Sta-Strap Interference with Throttle Cable Sleeve – 1992 75 thru 115

MARINER AND MERCURY

S/N 0D096367 thru 0D107109

Sta-Strap Locking Tab Contacting Throttle Cable Sleeve

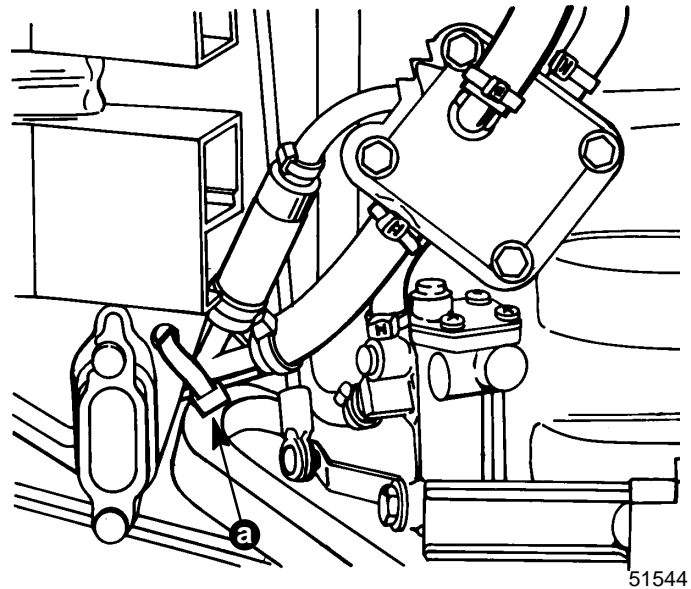
Inspect the sta-strap that holds the fuel line to the carburetor air intake. If the sta-strap locking tab is pointing straight out, it may contact the throttle cable sleeve at full throttle. This contact may prevent full throttle operation.

Turn the sta-strap until the locking tab is down and can not contact the throttle cable sleeve.

Sta-Strap Locking Tab in Correct Position
